Access Compliance Report

Public Rights-of-Way

(Curb Ramps)

Intersection ID: 49254	Main Street: OAKBURN_DR	Cross Street: LEGATO_LN	Location: SW
ADA ID: 4E274D0DC133	Ramp Type: Perp	Initial Pass/Fail: Fail	Overall Compliance: No
Severity Score: 35			
Codes/Mitigation Info/Possible Solution		Field Measurements/Component Compliance

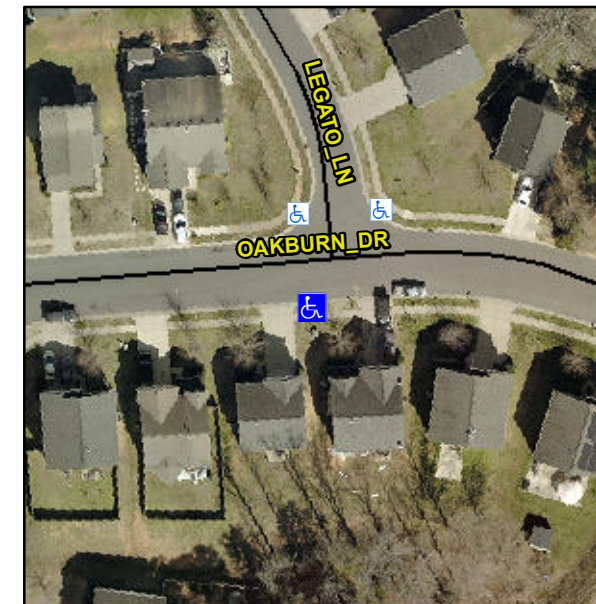
Not Found, R304.5.1, R304.2.2

Compliance	Description	Data	Compliance	Description	Data
N/A	Ramp Length (in)	46.5	No	Ramp Slope (%)	20.0
No	Ramp Width (in)	47.5	Yes	Ramp XSlope (%)	4.0
N/A	Flare Type LT	N/A	N/A	Flare Type RT	N/A
N/A	Flare Slope LT (%)	N/A	N/A	Flare Slope RT (%)	N/A
N/A	Flare Traversable LT?	N/A	N/A	Flare Traversable RT?	N/A
N/A	Landing Length (in)	N/A	N/A	DWS Provided?	N/A
N/A	Landing Width (in)	N/A	N/A	DWS Contrast?	N/A
N/A	Landing Slope (%)	N/A	N/A	DWS Length (in)	N/A
N/A	Landing X Slope (%)	N/A	N/A	DWS Full Width?	N/A
N/A	Landing Curb? (Y/N)	N/A	N/A	DWS Offset (in)	N/A
N/A	Shared Landing?	N/A			
N/A	Gutter Ponding?	N/A	N/A	Gutter Slope (%)	N/A
N/A	Gutter Lip Ht (in)	N/A	N/A	Gutter X Slope (%)	N/A
N/A	Painted X Walk1?	No	N/A	Painted X Walk2?	N/A
	X Walk 1 Direction	To N		X Walk 2 Direction	N/A
N/A	X Walk 1 Width (in)	N/A	N/A	X Walk 2 Width (in)	N/A
	X Walk 1 Slope (%)	1.0		X Walk 2 Slope (%)	N/A
	X Walk 1 X Slope (%)	4.1		X Walk 2 X Slope (%)	N/A

Remove & Replace Entire Ramp.
